ADDENDUM #1
EAST INTERCEPTOR SANITARY SEWER OVERFLOW STORAGE FACILITY – PHASE II
CITY OF DULUTH
PROJECT 0519SN
BID NUMBER 10-0272
MAY 20, 2010

NOTICE

DRAWING E-2

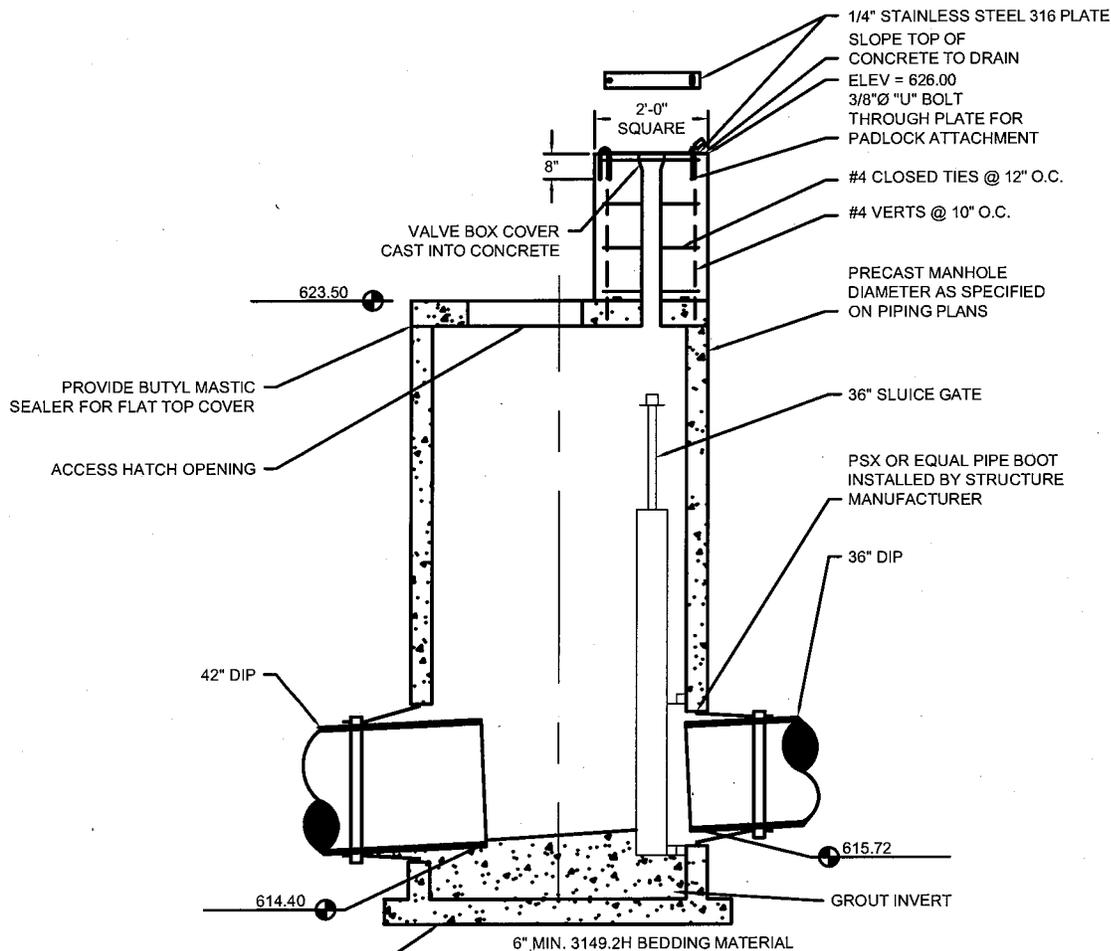
DELETE sheet E-2 and replace with the attached E-2.

3 PSMH 1 DETAIL
 G-11 NO SCALE

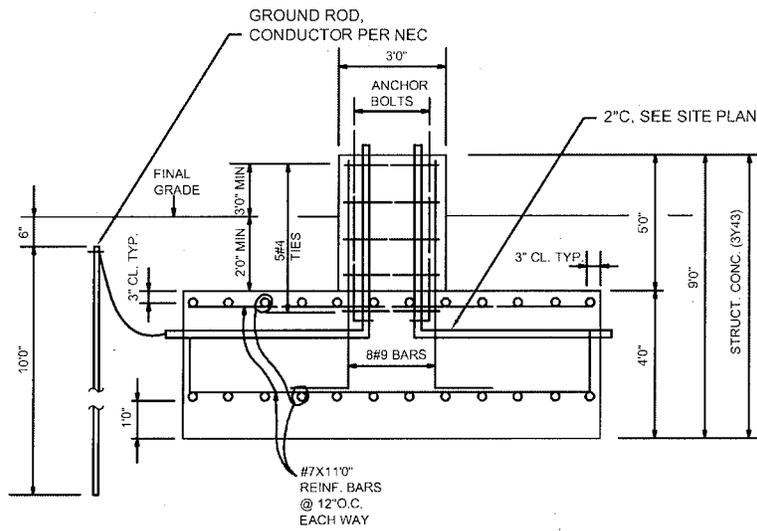
REPLACE detail 3/G-11 with the revised 3/G-11 attached to this document.

1. FORM GROOVED INVERT WITH GROUT IN ALL SANITARY MANHOLES. GROUT ENTIRE MANHOLE SECTION IN PSMH 1 TO PREVENT TURBULENCE FROM INVERT IN TO INVERT OUT.
